# 1 Calibration

## 1.1 Ongoing Performance Monitoring

**Figure 1: Tests with two LEDs on the board 1: signals measured at odd connectors 1 and 19 on the left side.**

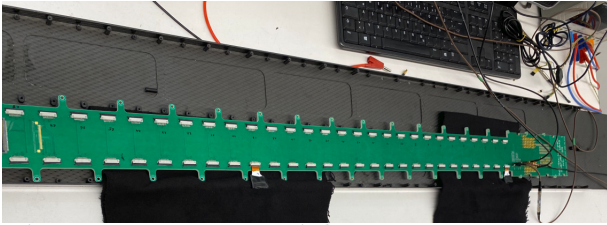
what is the benefit of this?
